Gila Mining, LLC
2619 Wellworth Way
West Friendship, MD 21794
September 19, 2019

**RE: Agency Review Comments and Request for Additional Information,
MOI Peru Mill Tailings Minimal Impact Exploration Project,
Permit No. LU038EM-Luna County, New Mexico**

The follow letter is a response to your September 16, 2019 state agencies comments letter to our *Minimum Impact Exploration Operation Permit Application Package* (PAP) (Permit No. LU038EM PAP). The purpose for the request for this permit is to perform initial resource assessment of the Peru Mill (PM) Tailings Pile. Your letter collectively contained the reviewing agency comment letters submitted by the following state agencies: the New Mexico Mining and Mineral Division (MMD), the New Mexico Environment Department ("NMED"), the New Mexico Office of the State Engineer ("NMOSE"), the New Mexico Department of Game and Fish ("NMDG&F"), and the New Mexico Department of Cultural Affairs - Historic Preservation Division ("NMDCA/HPD"). In addition to the State agencies the Ysleta del Sur Pueblo commented on our PAP.

Figure 1: Borehole Location Map & Affected Area Estimate

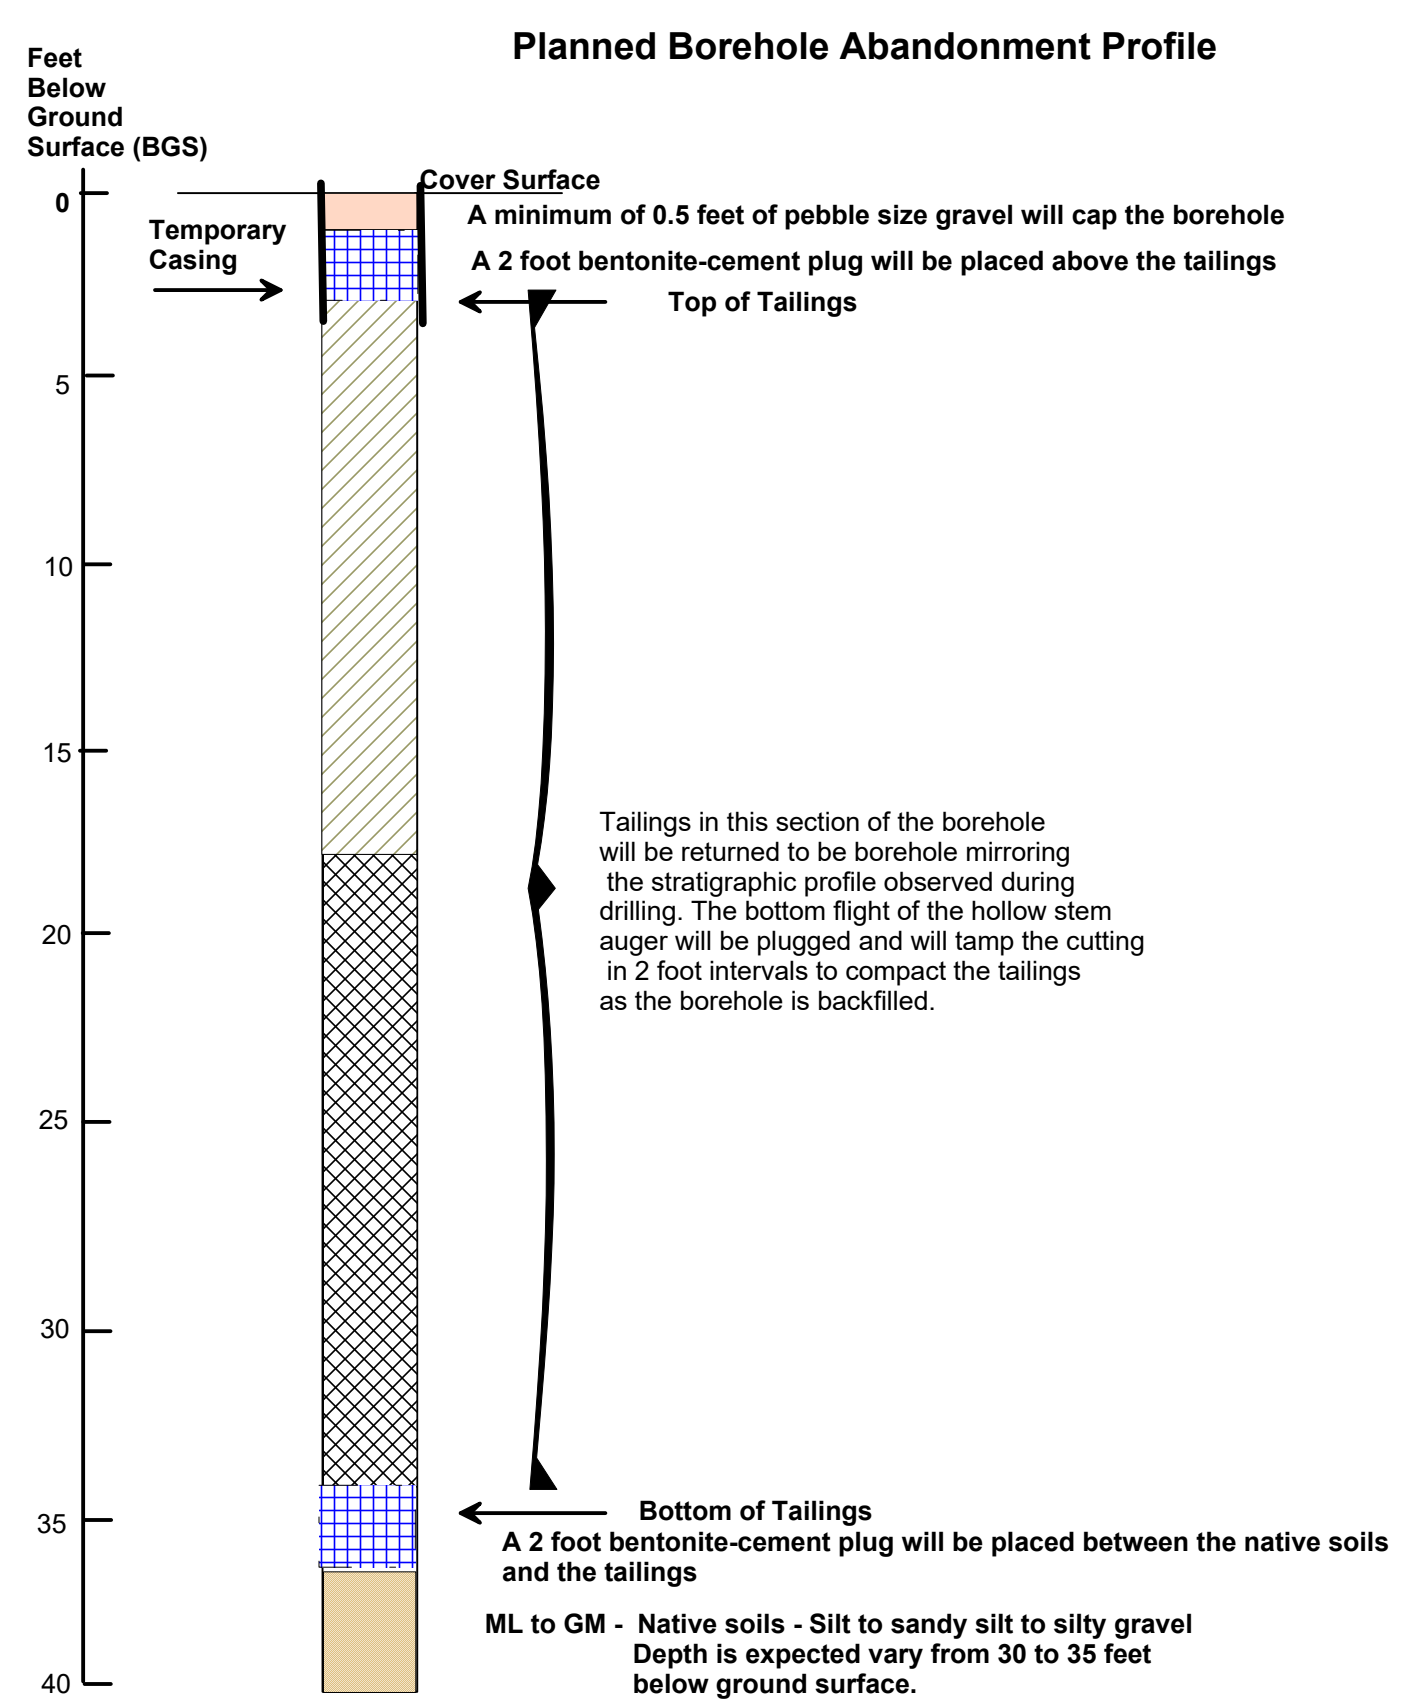
3. Section 7.D claims that there will be zero acres of disturbance. However, disturbance is likely with two trucks and one drilling rig. Please provide an estimate acreage of disturbance from overland travel, drilling activities, and any other disturbance, even if it seems minimal.

1. The PAP operator needs to amended from MOI Recovery Systems with Mr. Paul Forshey as point contact to Gila Mining, LLC ("GM") with myself, E. Terry Jensen as point of contact. Mr. Forshey is a management member of GM and will remain involved with this project. The address for GM is found in the above letter head.
2. GM requests the number of planned boreholes be amended from six to fifteen. The proposed borehole locations are illustrated on the attached Figure 1.

The following table presents our estimate.

<u>Road</u>	<u>Distance (Ft.)</u>	<u>Width (Ft.)</u>	<u>Area (Sq. Ft.)</u>	
South Pile Old Road	1056	5	5,280	
Access Path-South	2904	5	14,520	
Access Path-North	260	5	1,300	
			21,100	Sq. Ft.
			0.48	Acres

<u>Borehole Size</u>	<u>Borehole Area (Sq. Ft.)</u>	<u># of Borings</u>	<u>Area (Sq. Ft.)</u>	
Borings 4' x 4'	16	15	240	
Total Affected Area			21,340	Sq. Ft.
			0.49	Acres

The distances on the above table were estimated using Google Earth Pro. The width is the estimated width between the wheels of the trucks. GM recognizes the conservative nature of our estimate but this estimate reinforces limited disturbance to the surface of the tailings pile and if double the disturbance would still be less than an acre.

Figure 2: Tailings Soil Profile &Planned Borehole Abandonment Profile

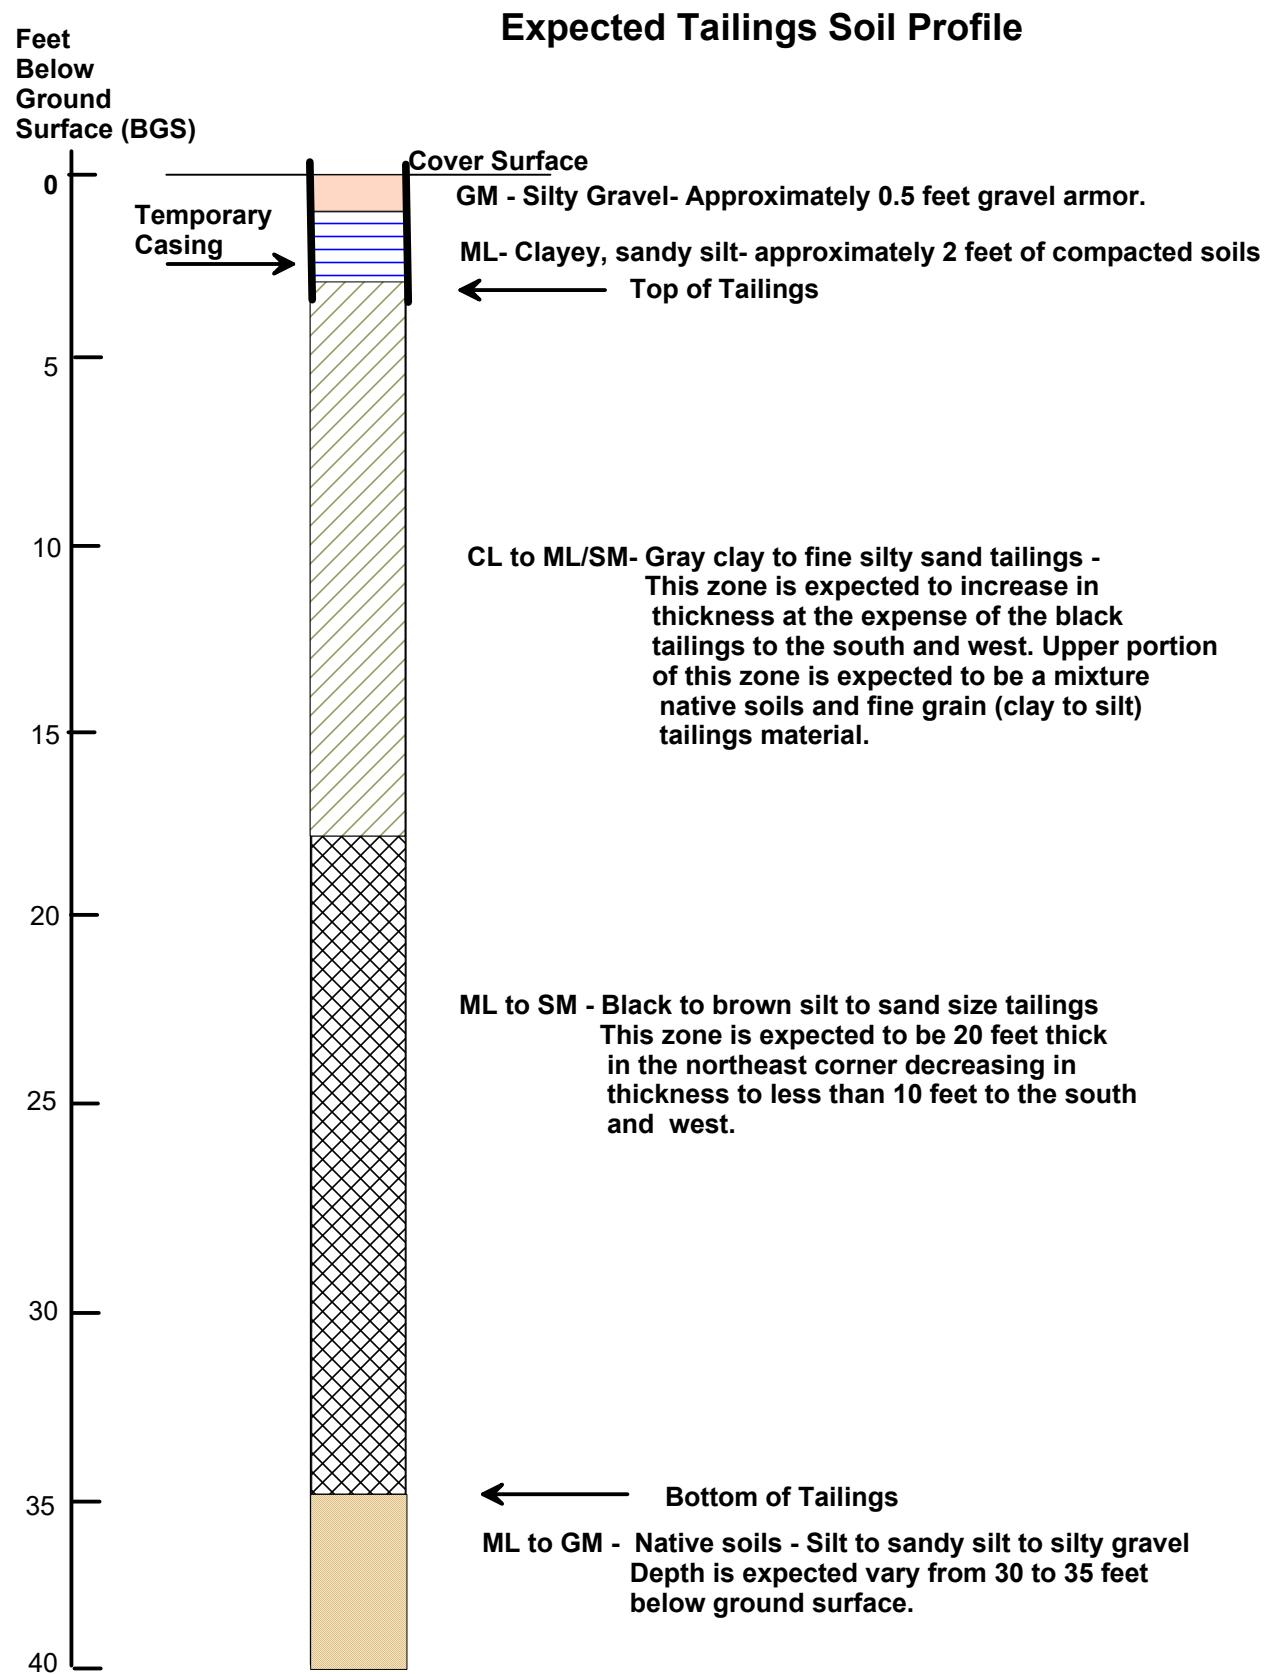
1. Section 4.D says excess drill cuttings will be buried at each drill location. It's unclear how the tailings will be buried or used for backfill. Note that Section 6.D says a bentonite slurry will be used for borehole abandonment. Provide a schematic that shows typical placement of sealant, drill cuttings and cover material to backfill boreholes as well as a clarification on containment and disposal of excess drill cuttings.

2. Provide more explanation about the plugging plan of operation from Section 6.D with an emphasis on the sequence of placing sealant and removal of hollow stem auger flights. There is some concern about the holes staying open before sealant is placed. Some drillers place sealant through the interior diameter of the auger flights, then remove flights in 5-foot sections.

Please see Figure 2 attached with this letter for additional details regarding our expectations for the tailings soil profile and our planned borehole abandonment. On the left side of Figure 2 the soil profile illustrates and describes the cover soil types, tailings variations and native soils. The right side of Figure 2 illustrates abandonment profile. As the figure shows the bentonite-cement slurry will be placed at the native soil & tailings

interface to limit vertical migration of fluids (if any) and at the top of the tailings between the tailings and cobble size gravel armor again to limit vertical migration of fluids (precipitation). GM contends this design will sufficiently maintain the State's design to isolate the tailing and mitigate any damage to the tailings cover integrity.

The driller will be instructed to compact the cuttings as the borehole is being backfilled. Any excess drill cuttings (tailings) will be containerized in 55-gallon drums. The cuttings will be sampled using USEPA SW-846 waste laboratory test methods, the drums will be appropriately labeled and stored off the tailings pile until the laboratory results are reported to GM. From those results the excess cutting will be recycled or disposed of following State and Federal guidelines for mining wastes.

During drilling and sampling, changes in tailings drill cuttings soil type will be logged with respect to depth. Upon completion of the drilling and sampling of the borehole, the driller will be instructed to backfill through the auger the staged native soil to one foot below the bottom of the tailings. During that backfilling the drill will use the augers with the internal plug to tamp and compact the native soils. The driller then tremie the bentonite cement slurry to the bottom of the auger and slowly retreat the auger up two feet to approximately one foot above the bottom of the tailings pile in the borehole. The driller will then be placed on stand-by for one hour allowing the bentonite cement slurry to set. Following the stand-by event, the tailings will be returned to be borehole mirroring the stratigraphic profile observed during drilling. The bottom flight of the hollow stem auger will tamp the cutting in 2-foot intervals to compact the tailings as the borehole is backfilled. A two-foot bentonite-cement plug will be placed at the top of the tailings in the borehole. This plug will be allowed to set for a minimum of 4 hours. The remainder of the borehole will be backfilled with the cobble size gravel armor.

Borehole abandonment will follow the plan defined in Figure 2 and MMD response Section 1,2, 4 & 5.
